BULLETINS

POSTED SET

# HAYDEN ELEMENTARY SCHOOL

## WESTMINSTER SCHOOL DISTRICT

SHEET D-2.2 - DEMOLITION FLOOR PLAN - BLDGS. 'D' & 'E'
Per Add #2

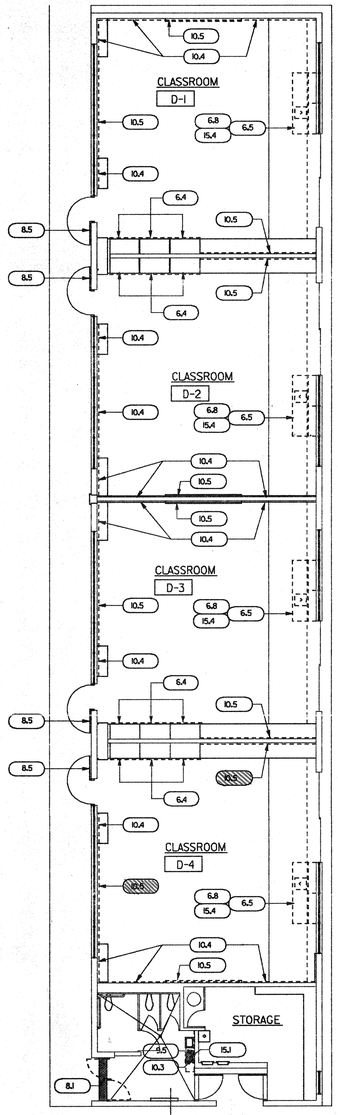
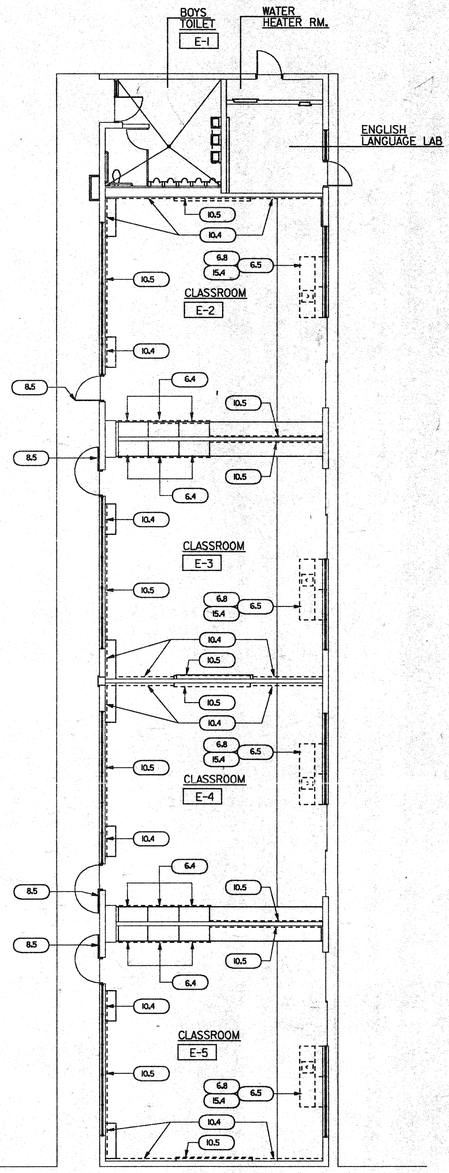
5. At Classroom D-4, DELETE Demolition Note 10.5 in its entirety.

| SCALE: 1/4"=1'-0" | EXCERPT FROM SHT. D-2.4 | DSA#: 04-100993 | FILE#: 50-45 |

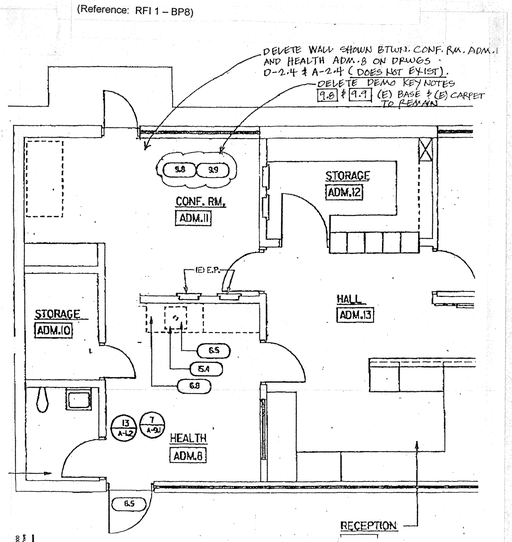
ISSUE CHANGE DRAWING CD-1 - Delete Demo. Keynotes 9.8 and 9.9 dated 4/14/00

1. DELETE Demolition Keynotes 9.8 and 9.9.
   DELETE wall between Admin-8 and Admin-11 on Sheets D-2.4 and A-2.4.
   Wall does not exist.

SHEET A-2.1 - FLOOR PLAN - BLDGS. 'B' & 'C'

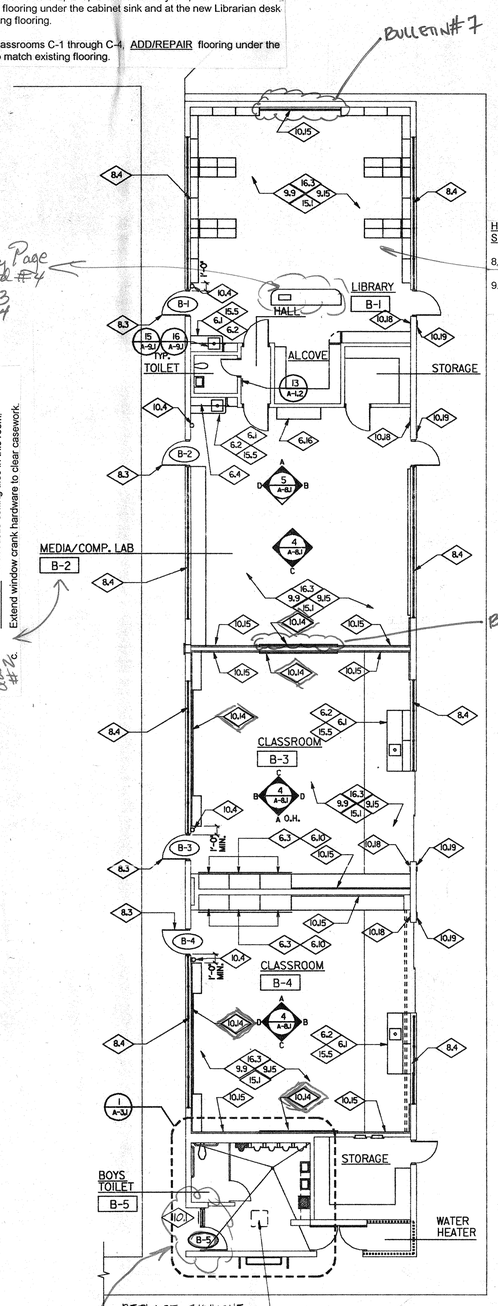
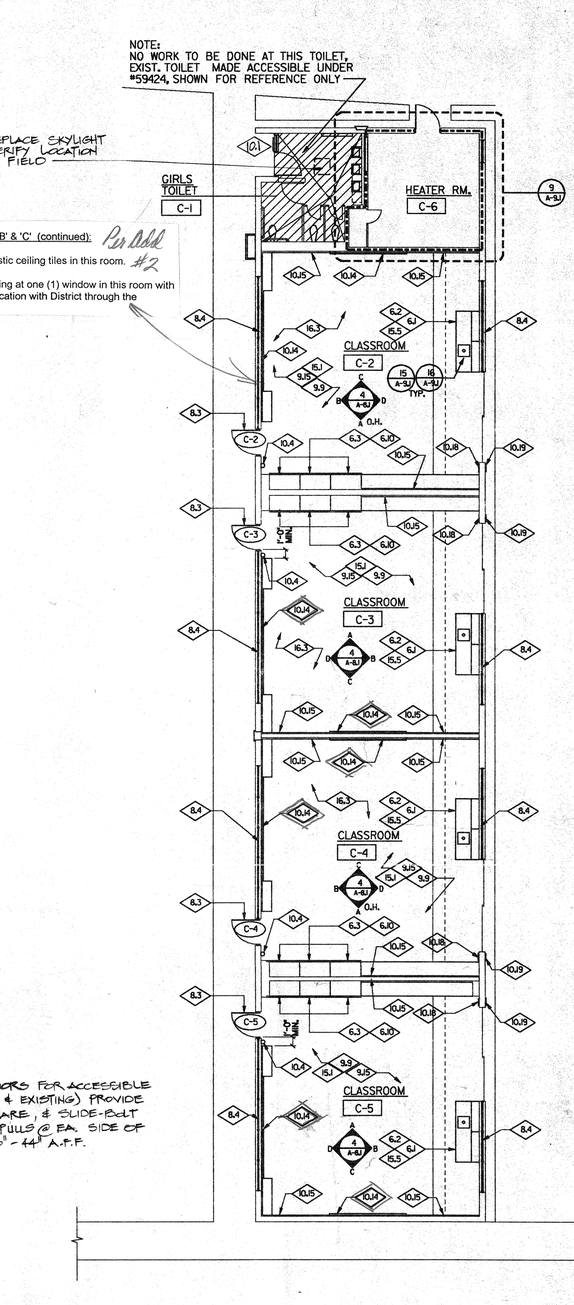
1. At Bldg. B – Library Room, all Library circulation desks are in Contract, and provide power pole from ceiling (no floor cutting) for power and data to desk.
2. At Bldg. B - Classrooms B-2, B-3, B-4 and Library B-1, ADD/REPAIR flooring under the cabinet sink and at the new Librarian desk to match existing flooring.
3. At Bldg. C - Classrooms C-1 through C-4, ADD/REPAIR flooring under the cabinet sink to match existing flooring.

6. At Room B-2 Media/Computer Lab, ADD the following:
   a. REPLACE scratched Lexan panels in this room with 1/4" Solar-bronze glazing. Verify quantity in field.
   b. REPLACE all acoustic ceiling tiles in this room.
   c. Extend window crank hardware to clear casework. Per Add #2

7. At Boys' Toilet B-5, REPLACE both hollow metal door frames and doors as shown on Plan and replace birdscreen and louvers above Door B-5. Also see Schedule on Sheet A-7.1 Provide H.M. doors and frames. Per Add #2

8. At Library B-1, REPLACE all acoustic ceiling tiles in this room.
9. At Classroom C-2, REPLACE glazing at one (1) window in this room with 1/4" Solar-bronze glazing. Verify location with District through the Construction Manager.

SHEET A-2.2 - FLOOR PLANS, BUILDINGS 'D' & 'E' Per Add #4

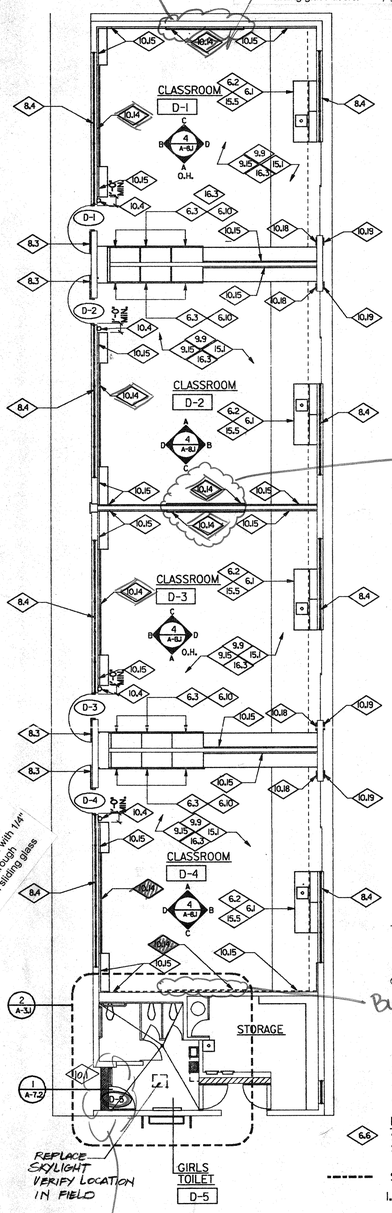
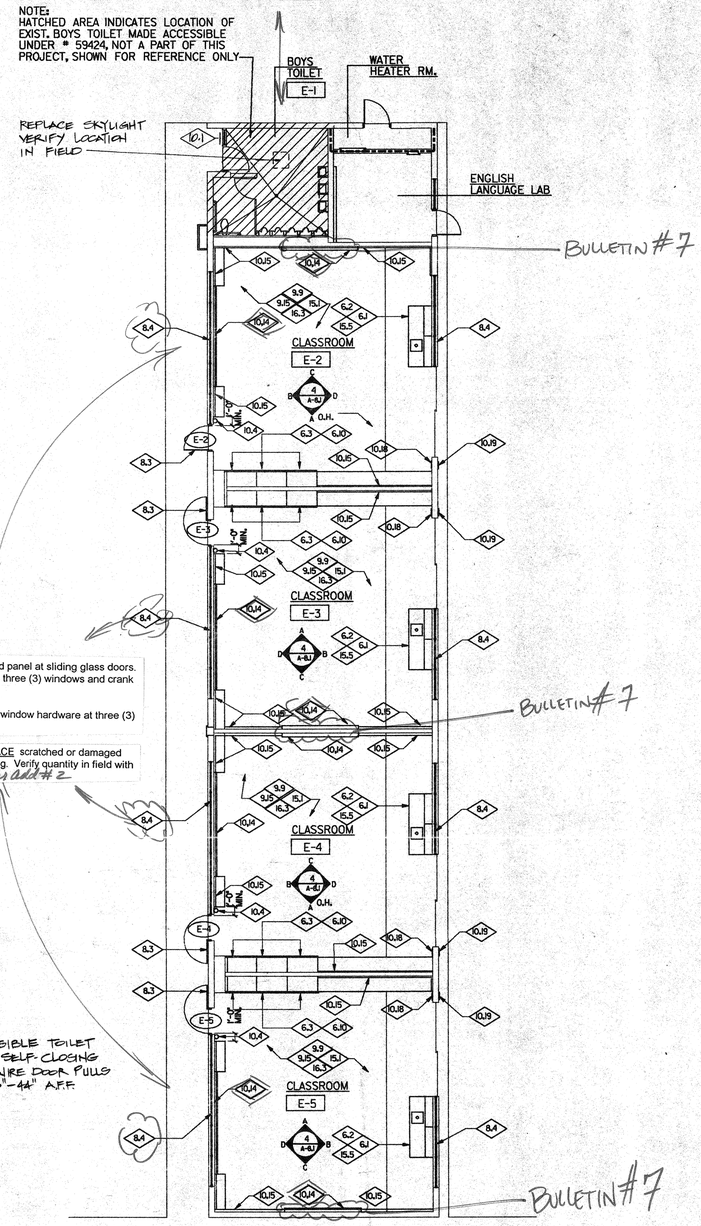
4. At Bldg. D - Classrooms D-1 through D-4, ADD/REPAIR flooring under the cabinet sink to match existing flooring.

5. At Bldg. E – Classrooms E-1 through E-4, ADD/REPAIR flooring under the new sink to match existing flooring.

10. At Classroom D-1, REPLACE scratched Lexan window panes or damaged panes with 1/4" Solar-bronze glazing. Verify quantity in field with District through Construction Manager. REPLACE scratched glazing on sliding glass doors. Per Add #2

11. At Classroom D-4, REPLACE scratched Lexan window panes with 1/4" Solar-bronze glazing. Verify quantity in field with District through Construction Manager. REPLACE scratched glazing on sliding glass doors. Per Add #2

12. At Classroom D-4, DELETE Construction Note 10.14 in its entirety. Per Add #2

13. At Girls' Toilet D-5, REPLACE both hollow metal door frames and doors as shown on Plan and REPLACE birdscreen and louvers above Door D-5. Also see Schedule on Sheet A-7.1. Provide hollow metal doors and frames. Per Add #2.

15. At Classroom E-2, REPLACE glass on fixed panel at sliding glass doors. REPLACE chain-driven window hardware at three (3) windows and crank hardware. Per Add #2

16. At Classroom E-5, REPLACE chain-driven window hardware at three (3) windows with crank hardware.

SHEET A-2.3 - FLOOR PLAN - KINDERGARTEN BLDG. 'K'

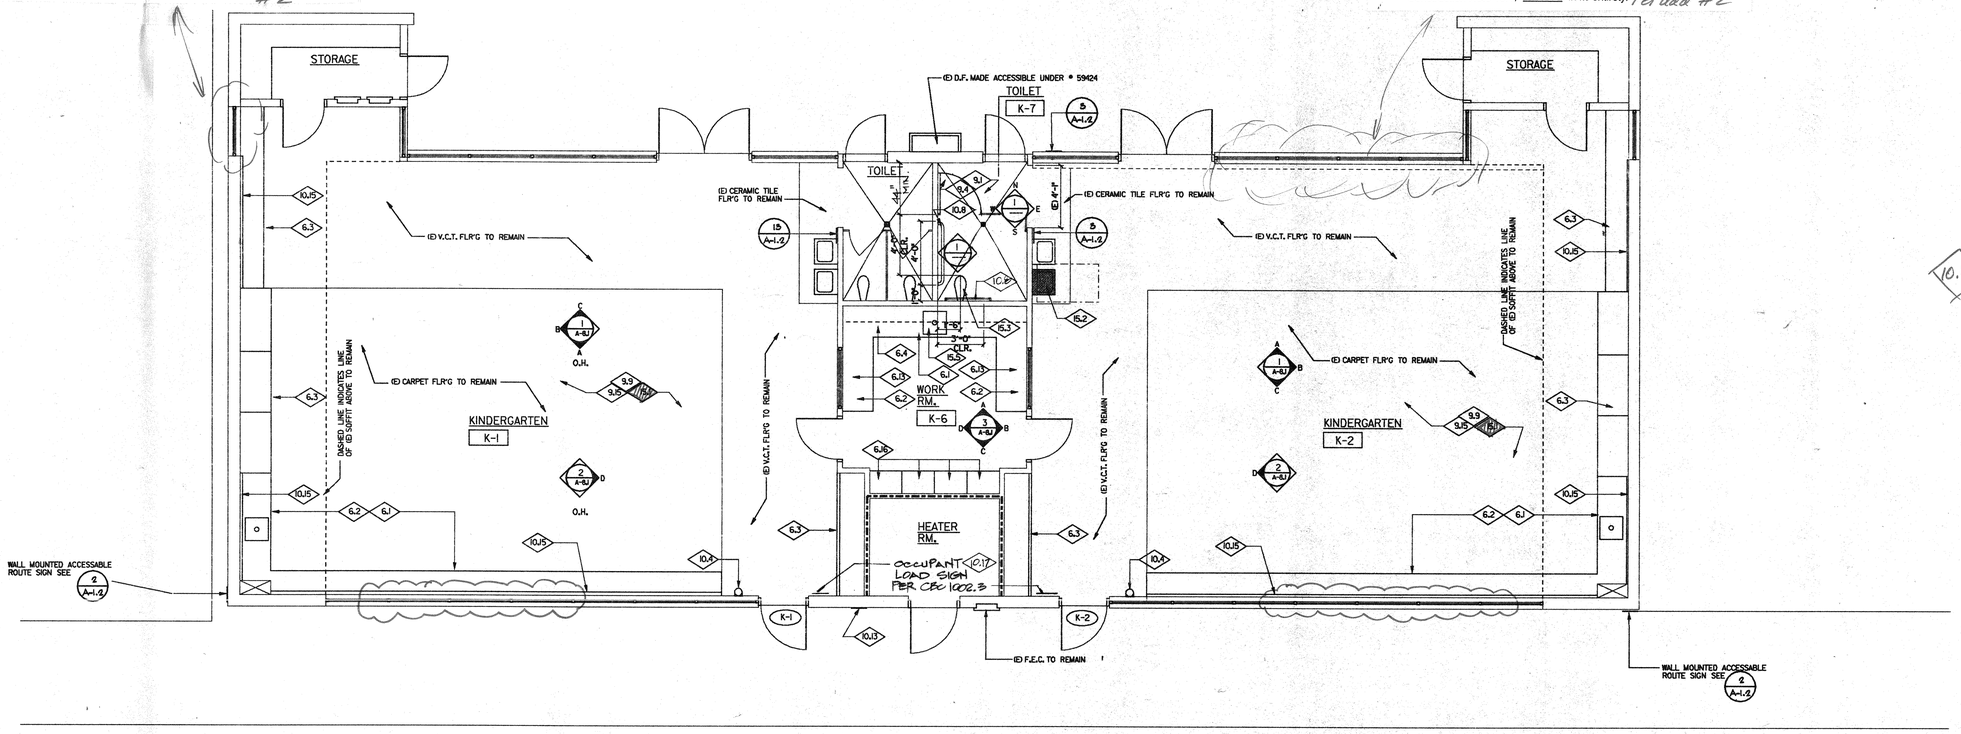
19. At Kindergarten Room K-1, replace window at northwest corner of room including all flashing and sealant. Repair interior wall surface around this window damaged by water. At ten (10) feet to the east of this window, repair spalled plaster at wall corner. Construction Note 15.1, DELETE in its entirety. Per Add #2

20. At Kindergarten Room K-2, replace scratched window panes at north wall. Verify quantity in field with District through Construction Manager. Construction Note 15.1, DELETE in its entirety. Per Add #2

10.14 1 per classroom per add #4

SHEET A-2.4 - FLOOR PLANS, ADMIN. BUILDING Per Add #4

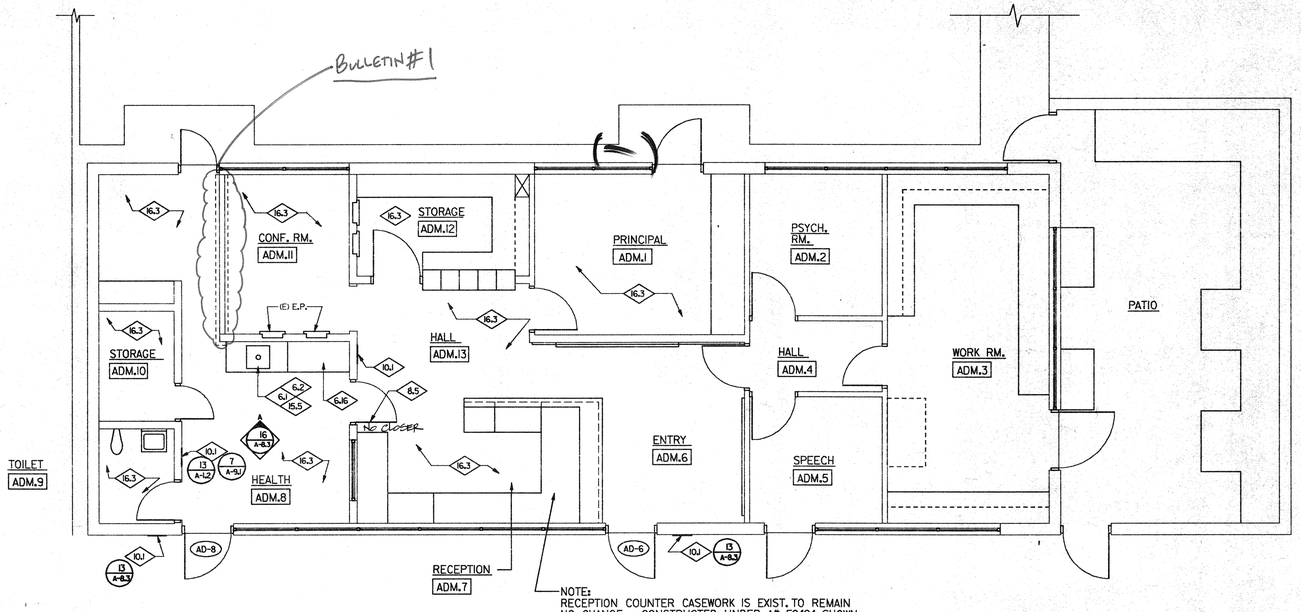
7. At Health ADM-8, ADD/REPAIR flooring under the cabinet sink to match existing flooring.

| SCALE: 1/4" = 1'-0" | EXCERPT FROM SHT. D-2.4 | DSA#: 04-100993 | FILE#: 30-43 |

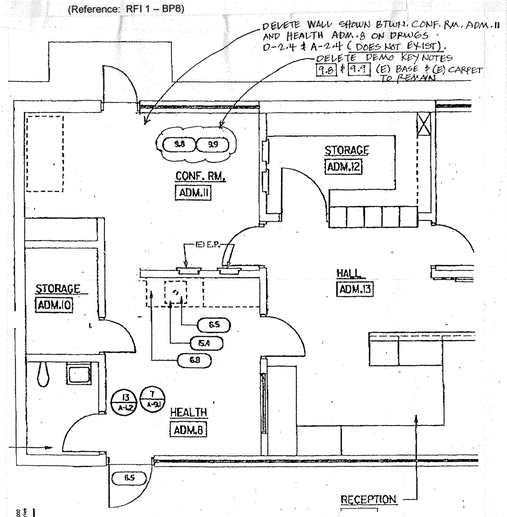
ISSUE CHANGE DRAWING CD-1 - Delete Demo. Keynotes 9.8 and 9.9 dated 4/14/00

1. DELETE Demolition Keynotes 9.8 and 9.9.
DELETE wall between Admin-8 and Admin-11 on Sheets D-2.4 and A-2.4. Wall does not exist.

**ISSUE CHANGE DRAWING CD-11** - Interior Elevation at Tackboard dated 8/15/2000.

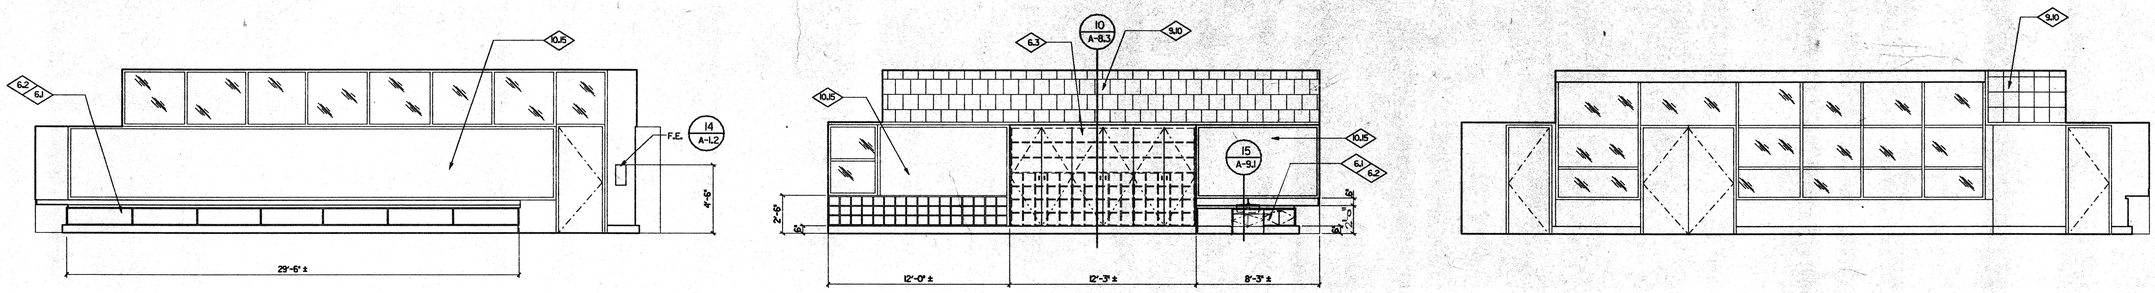
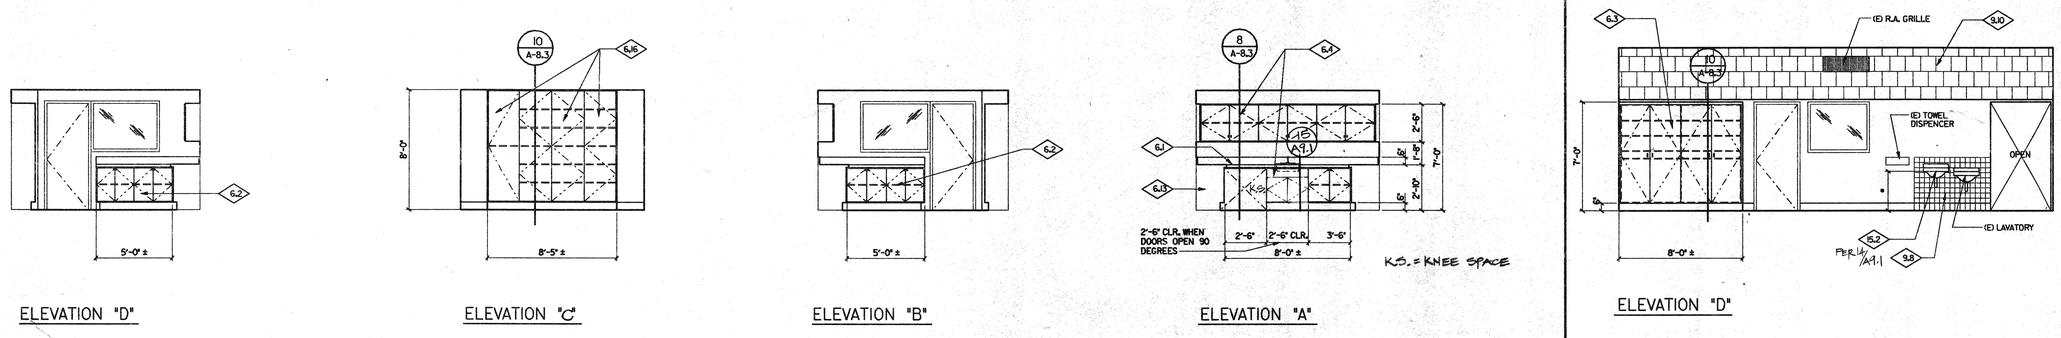
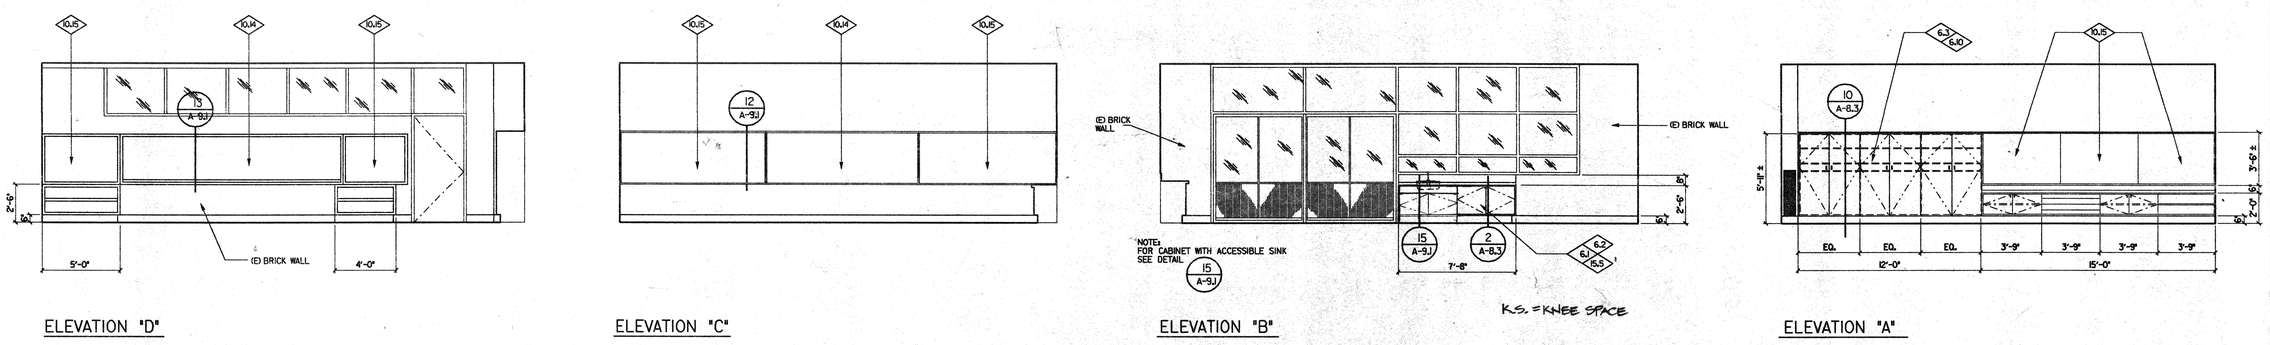
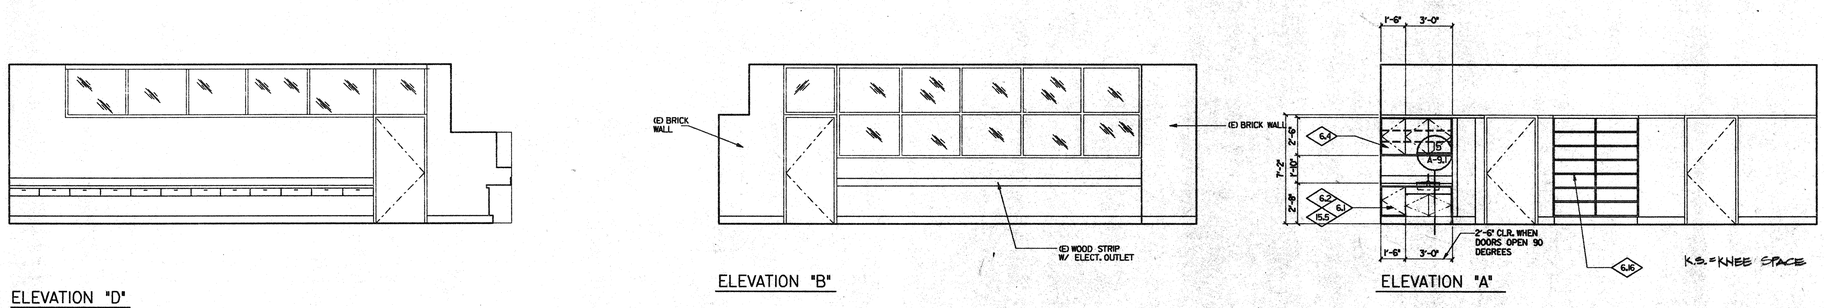
1. Trim tackboard at wet area as required to accommodate new casework in accordance with Change Drawing CD-11.

## GRAB BAR DETAIL (11)
3" = 1'-0"

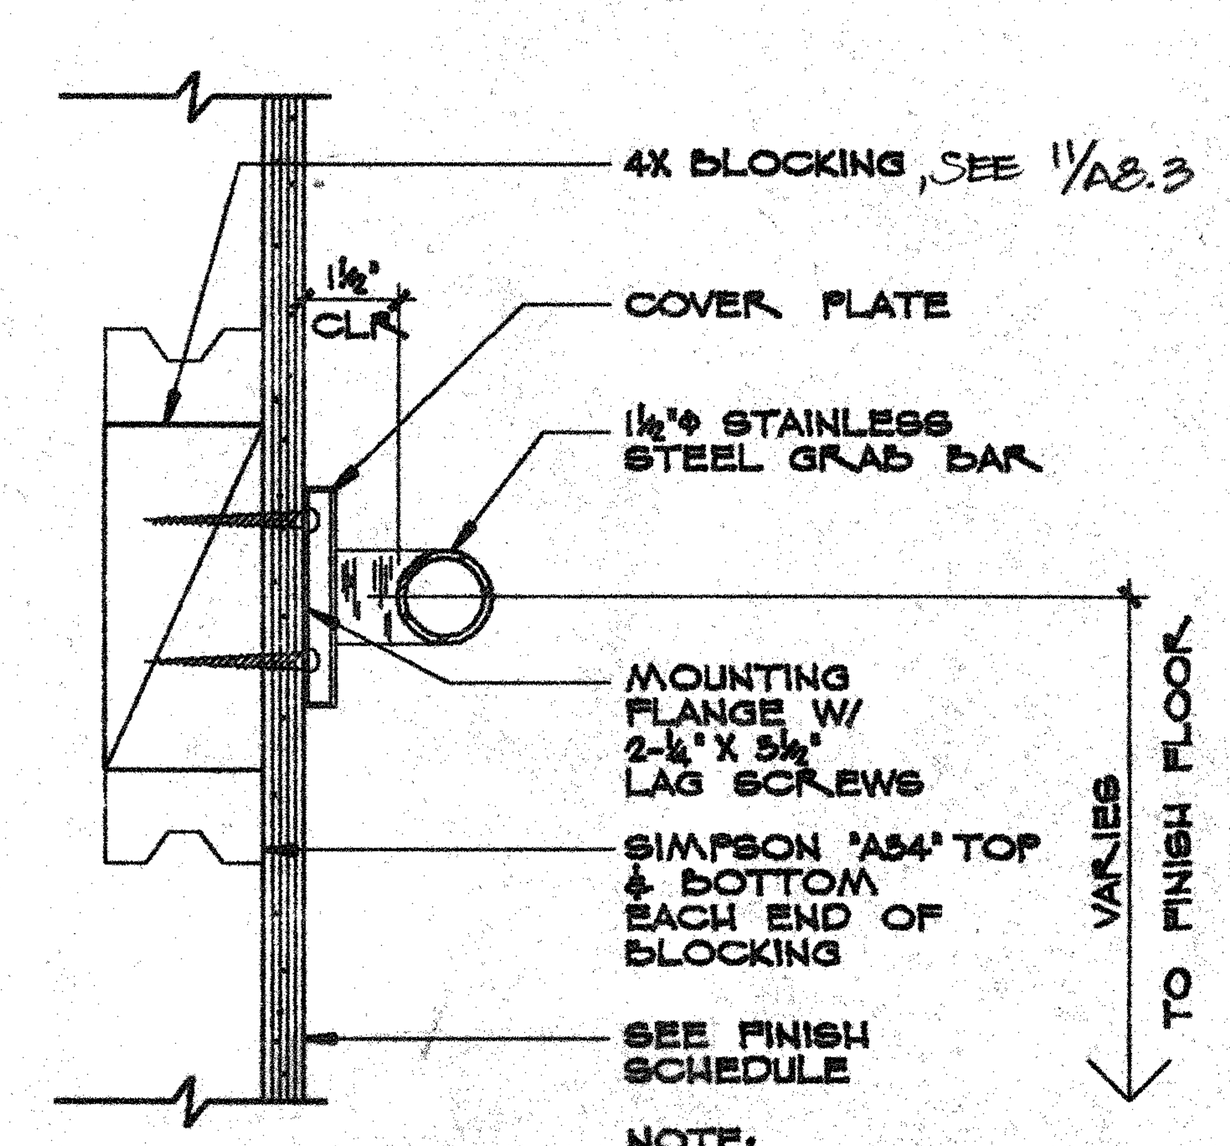
22. Detail 11 on Sheet A-9.1, fill in the empty detail bubble with "14/-".
